BID ADDENDUM # 2

**Health Center Air Handler Replacement Project, Project Number 13818
California State University Stanislaus
One University Circle, Turlock, CA 95382**

**Bid / Project Number: 13818
Bid Opening Date:March 25, 2021
Bid Opening Time:2:00 p.m.**

LT GA WALL DUCT OPENING

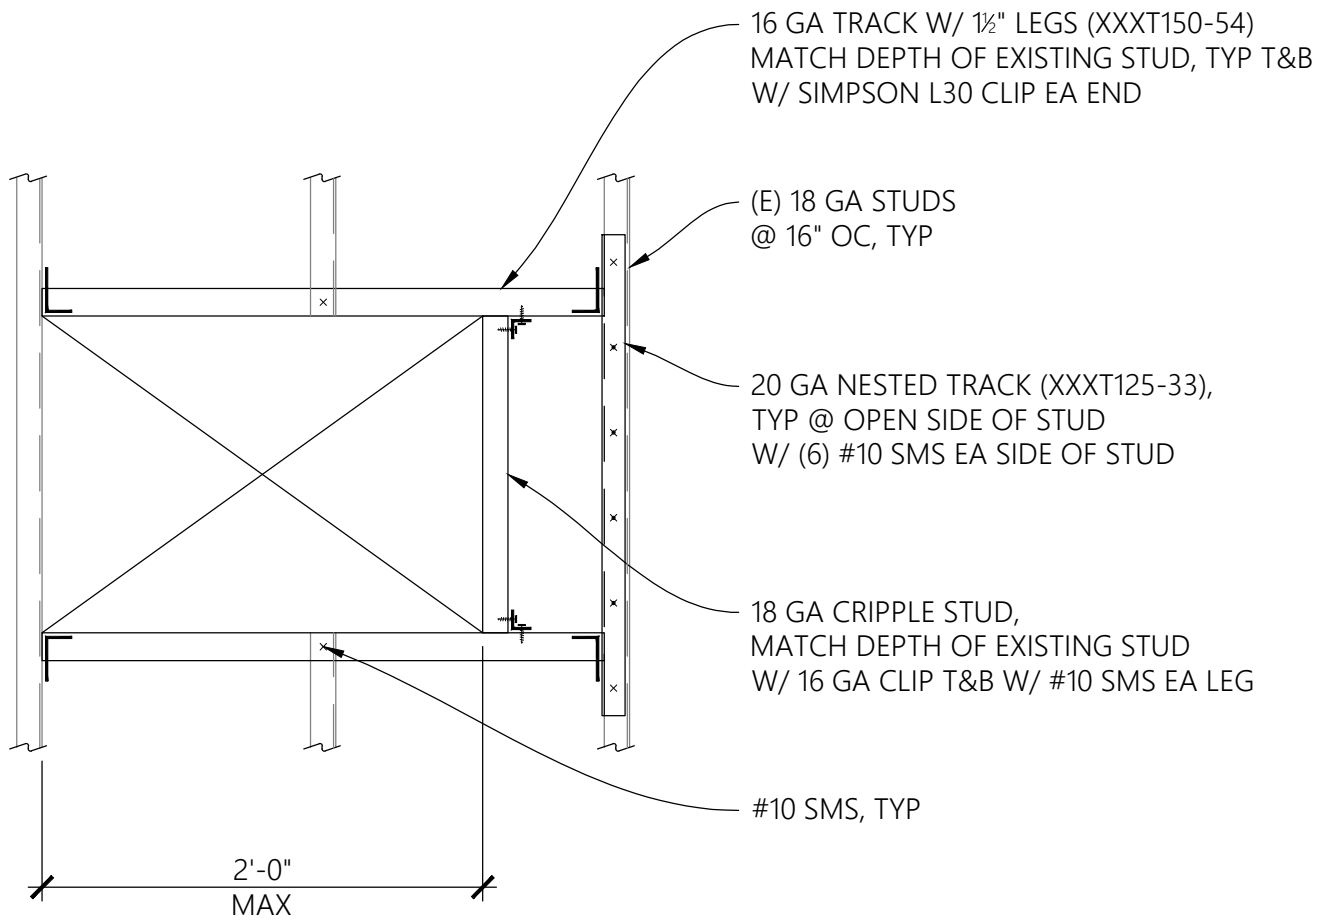
1. On detail 2/M-2 there is the phrase “(N) FRAMED OPENING IN WALL, SEE STRUTURAL DRAWINGS”. We are unable to find it on the structural drawings, please supply the necessary drawing.

Please see attached drawing for Framed Opening in Wall.
